UK Healthcare Richmond Improvements

ADDENDUM # 3

Addendum #03

Client	University of Kentucky Healthcare	Date	2025-03-21
Project	UK Richmon MOB	UK Project #	12566, 12567, 12568, 12569
	UK - CCK-1256x-1-25	Champlin Project #	514-7484

1 FIRST FLOOR - PLUMBING NEW WORK PLAN
SCALE: 1/8" = 1'-0"

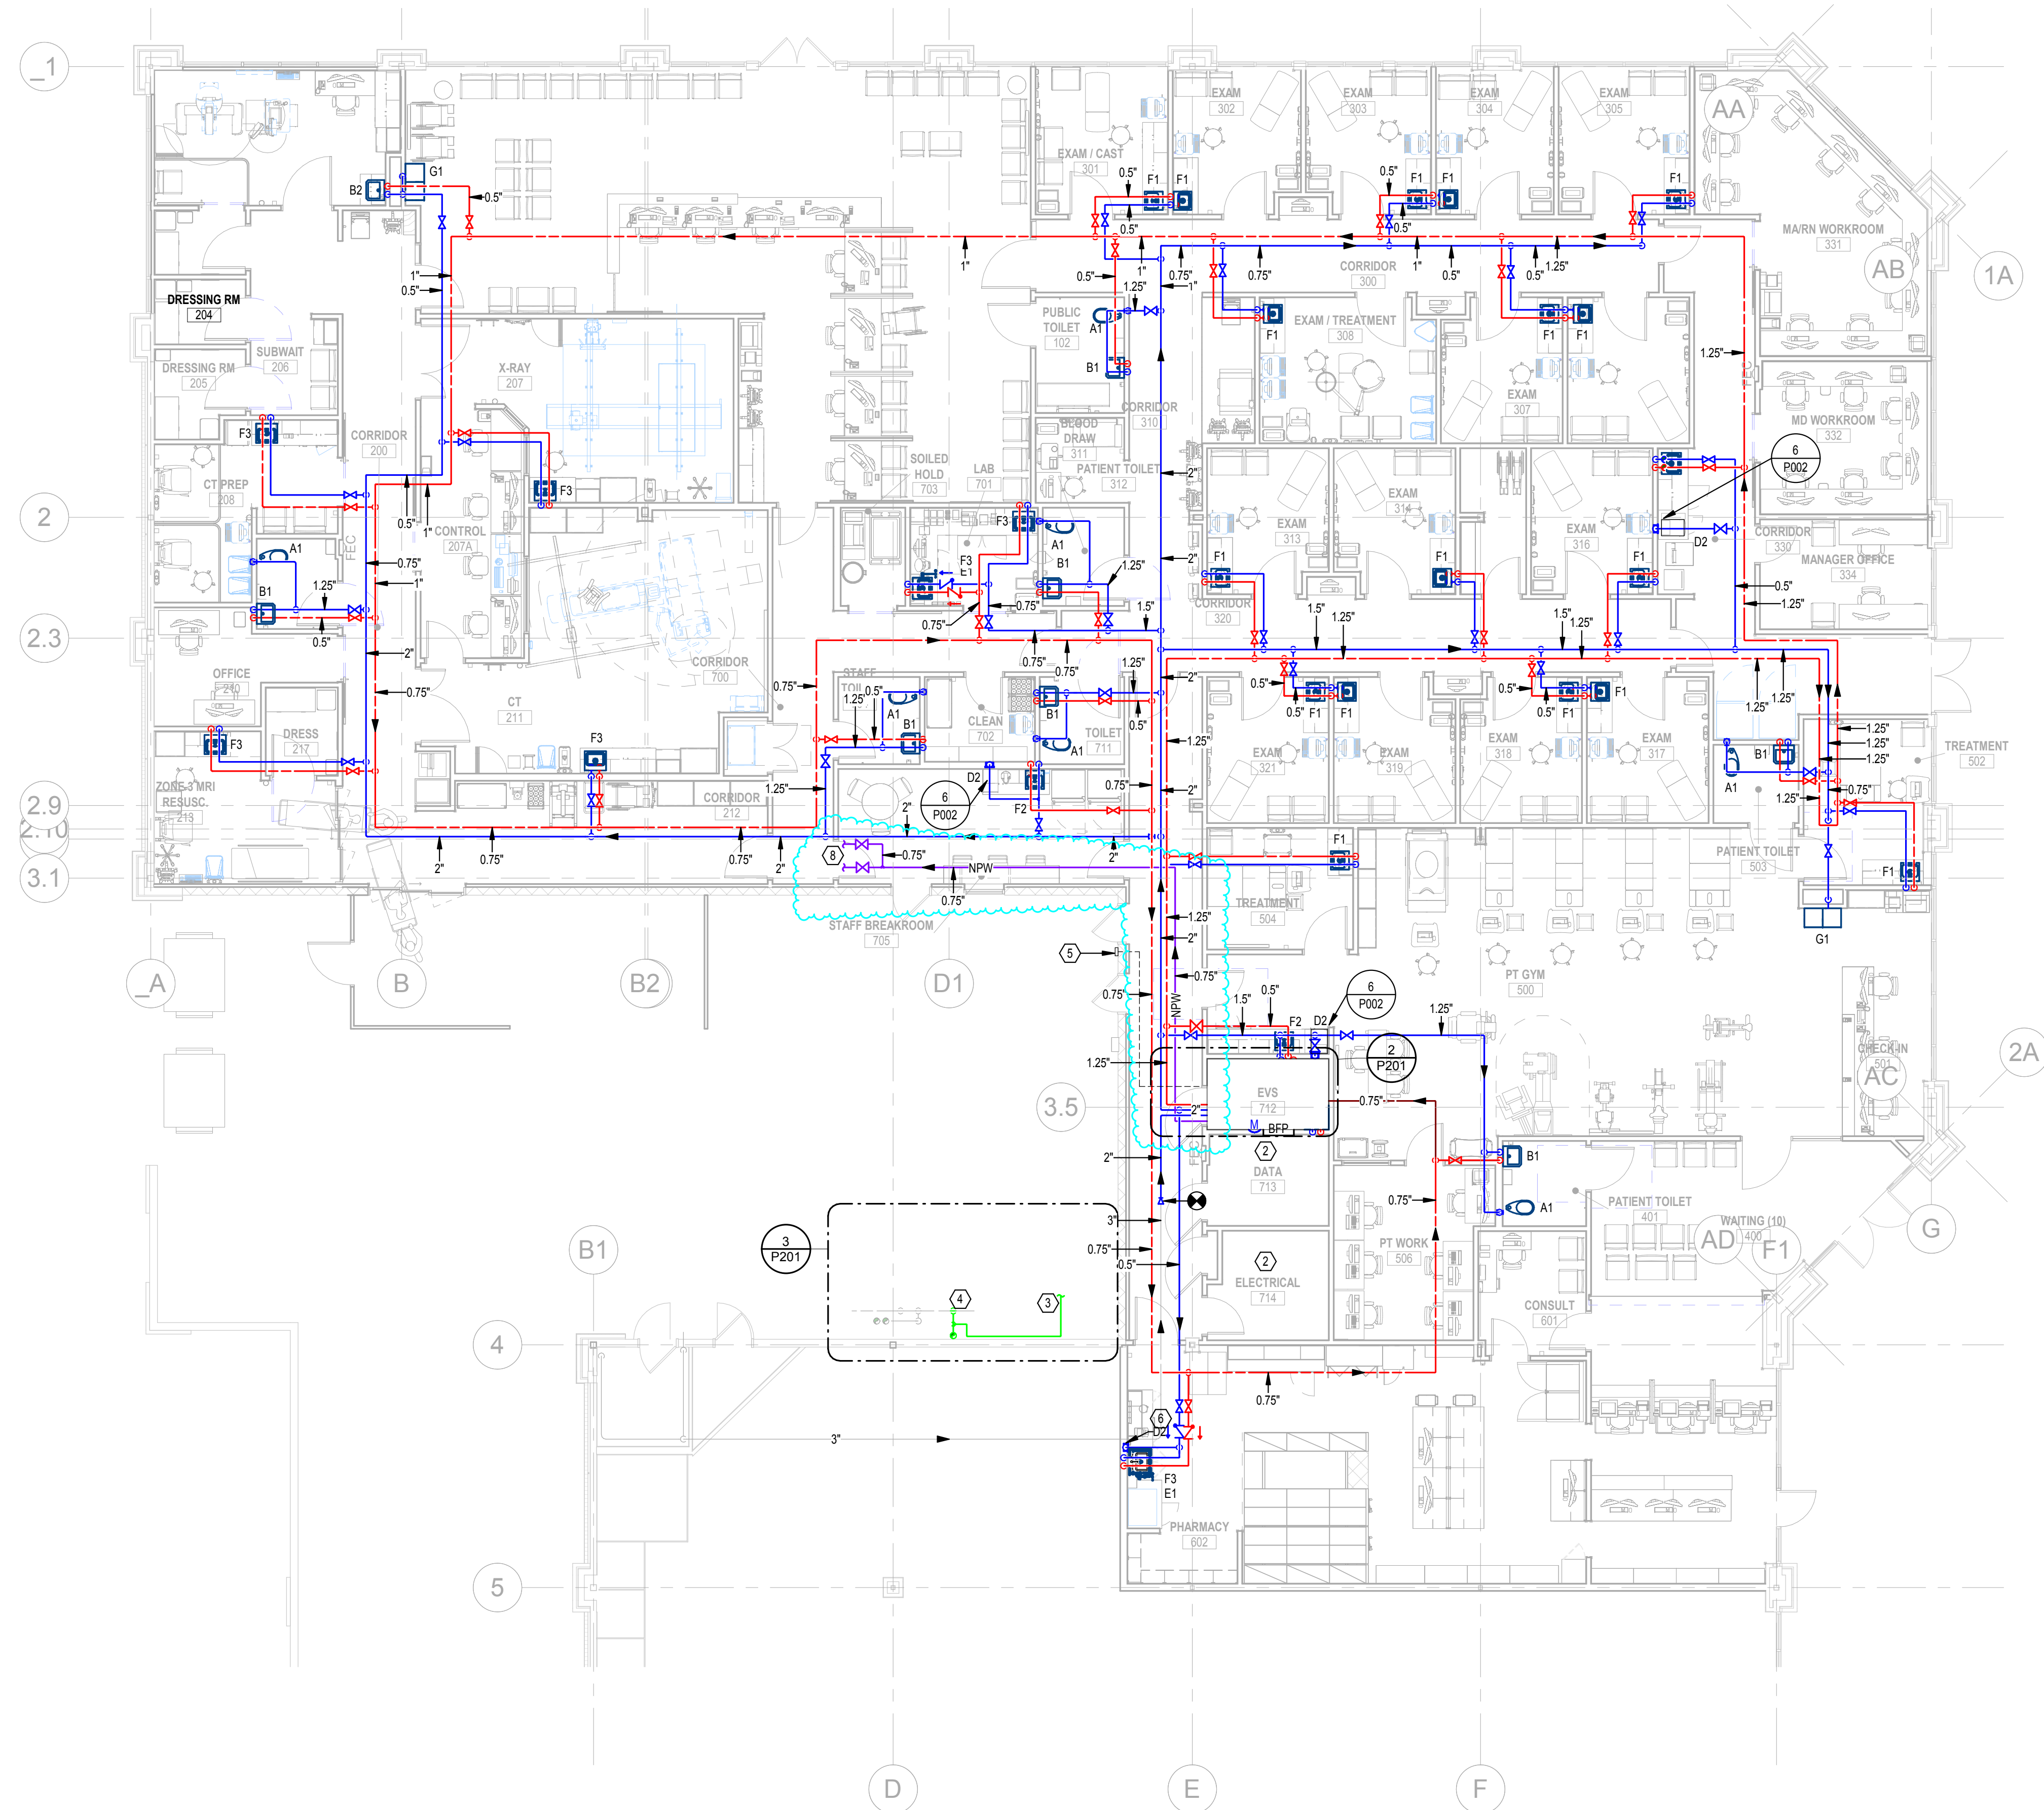
1. Added Notes 7 & 8
2. Added 0.75" Backflow Preventer and associated cold water (NPW) to serve humidifiers.

7. PROVIDE 0.75" BACKFLOW PREVENTER. BASIS OF DESIGN WATTS LF099 OR EQUAL. PROVIDE AIR GAP FITTING AND ROUTE DRAIN LINE TO ADJACENT MOP-SINK.
8. EXTEND 0.75" NPW TO MECHANICAL EQUIPMENT. COORDINATE EXACT LOCATION WITH MECHANICAL CONTRACTOR PRIOR TO INSTALLATION.

ROOFTOP UNIT CONTROLS DIAGRAM

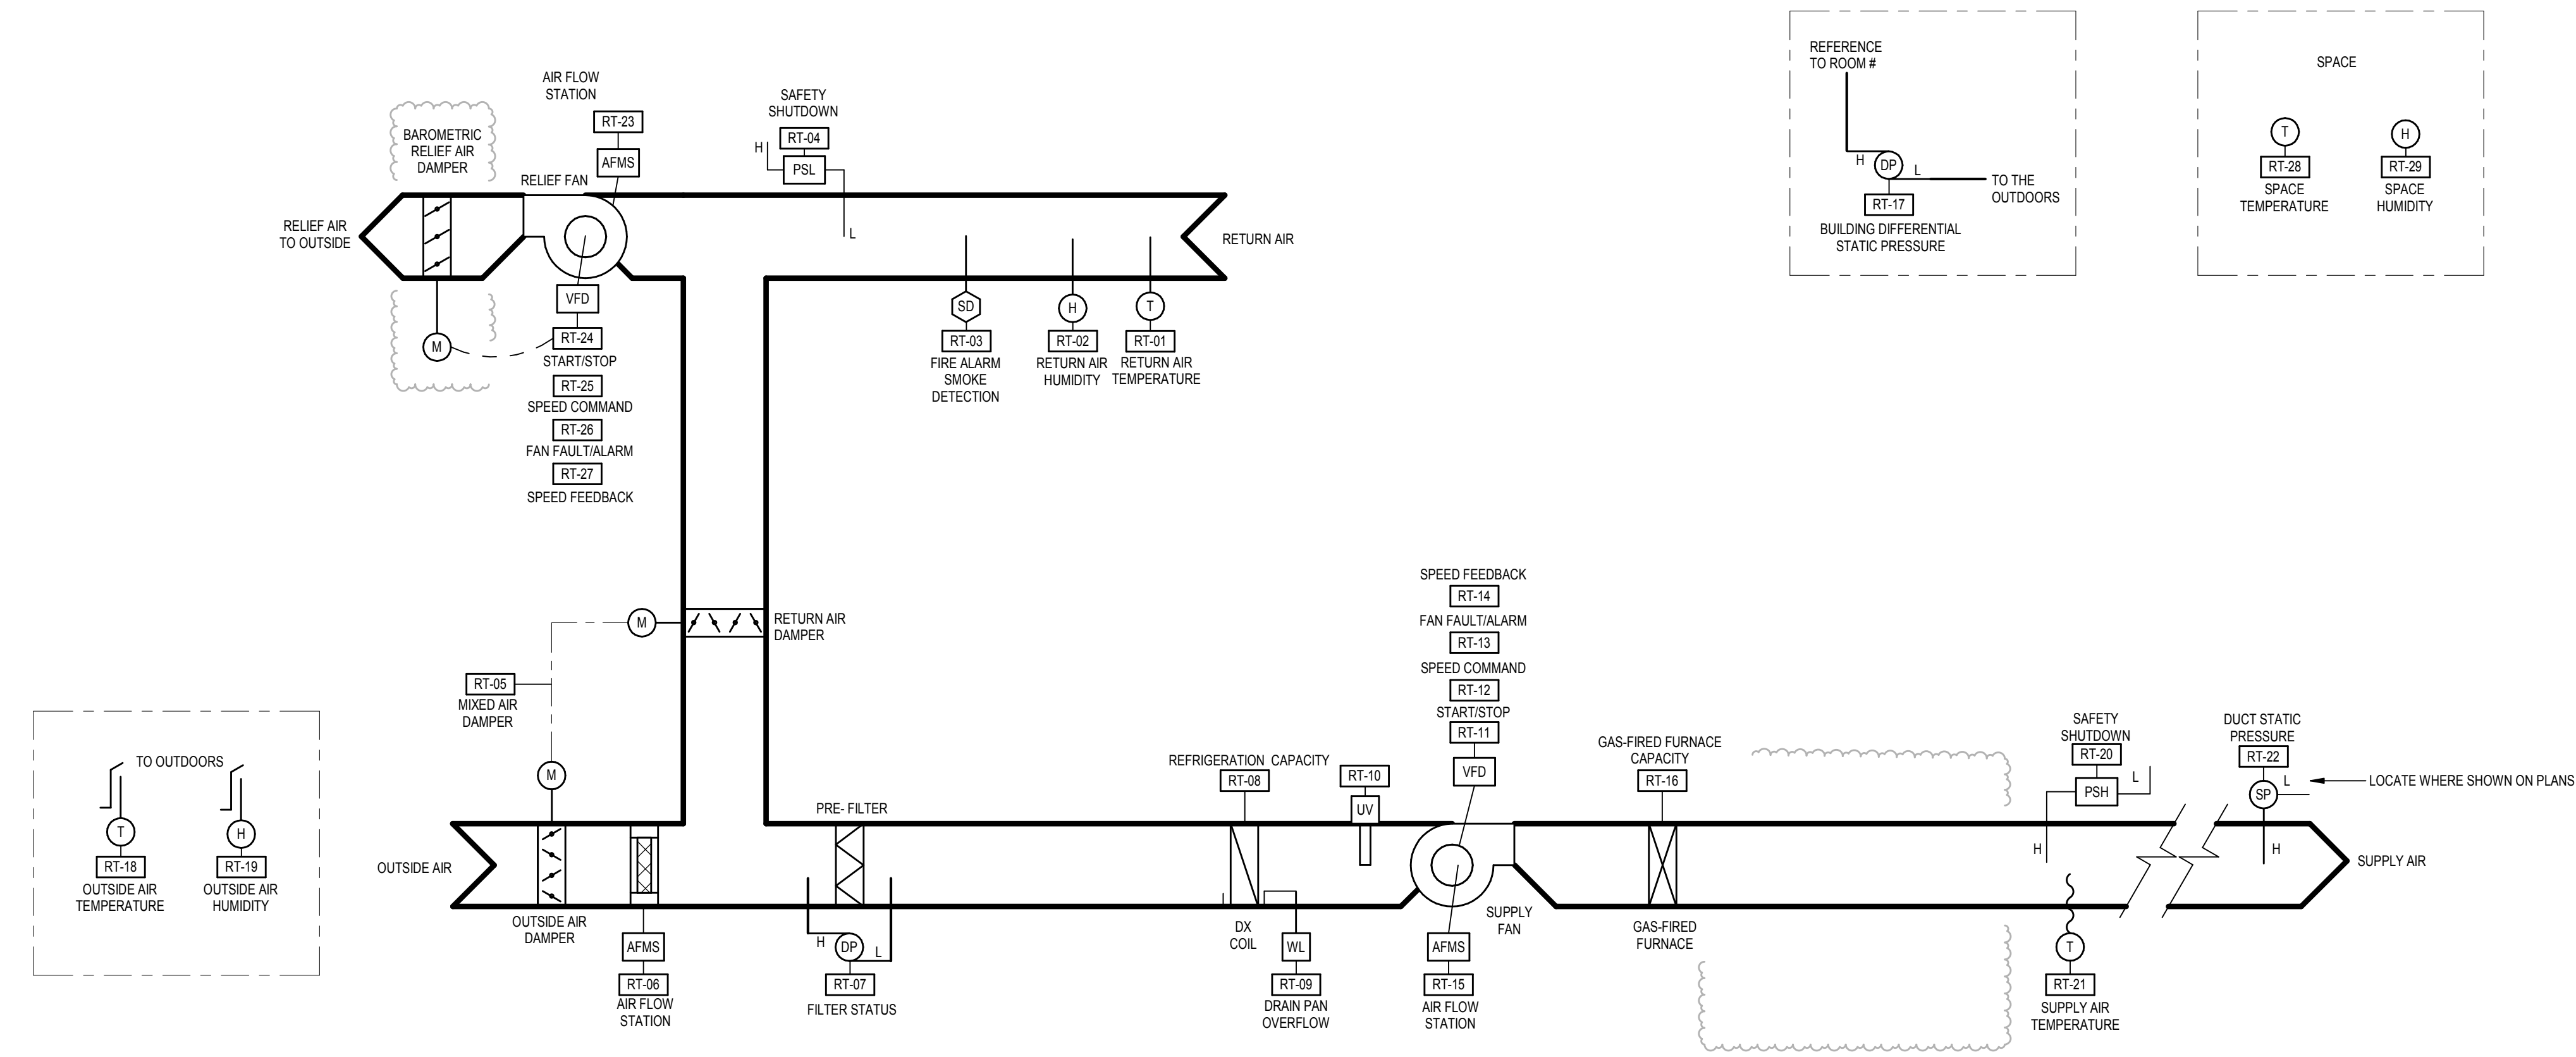
1. Change relief air damper from motorized to barometric on controls diagram.
2. Remove freeze-stat from controls diagram and associated control point on schedule.
3. Remove final filter from controls diagram and associated control point on schedule.
4. Remove UVGI light from controls diagram and associated control point on schedule.
5. Remove unused control points from schedule. Renumber control points to account for these removals.

1 FIRST FLOOR - MECHANICAL NEW WORK PLAN
 SCALE: 1/8" = 1'-0"

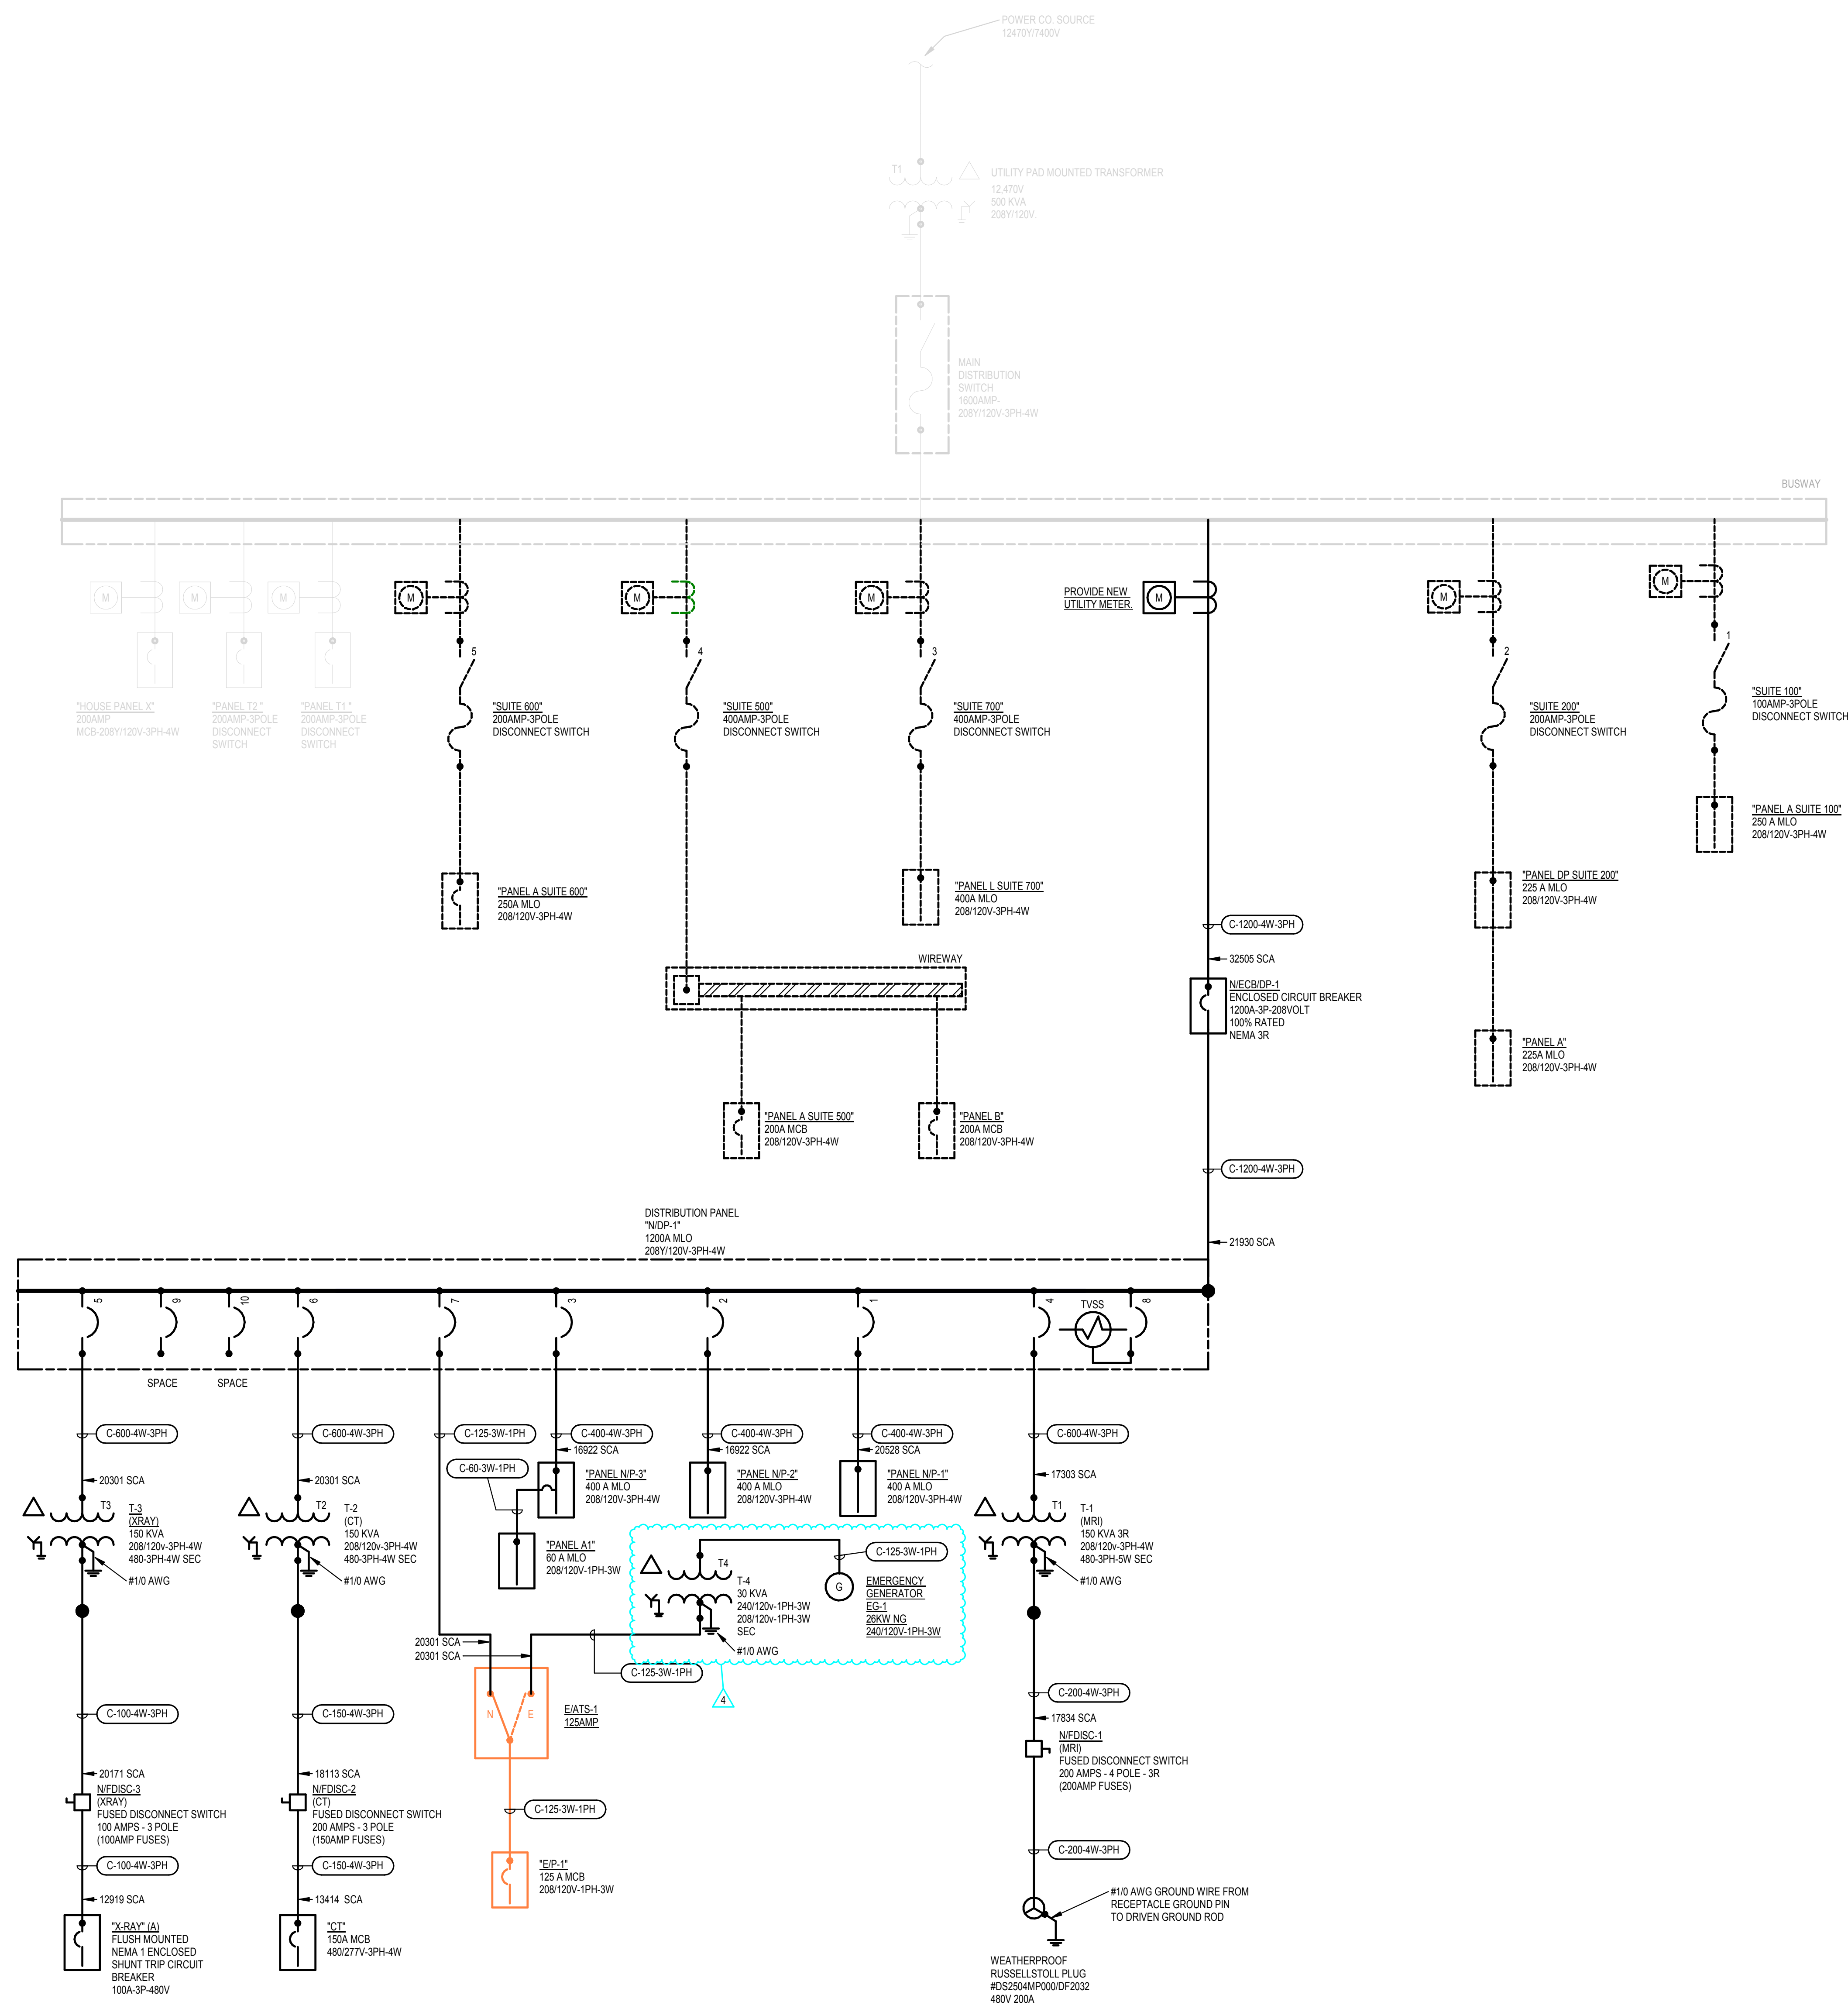
1. Relocate steam generators. Reroute steam piping to dispersion grids to account for new location.
2. Relocate condensate pipe routing for steam generators/dispersion grids. Drain is to be located in CT EQUIP closet.
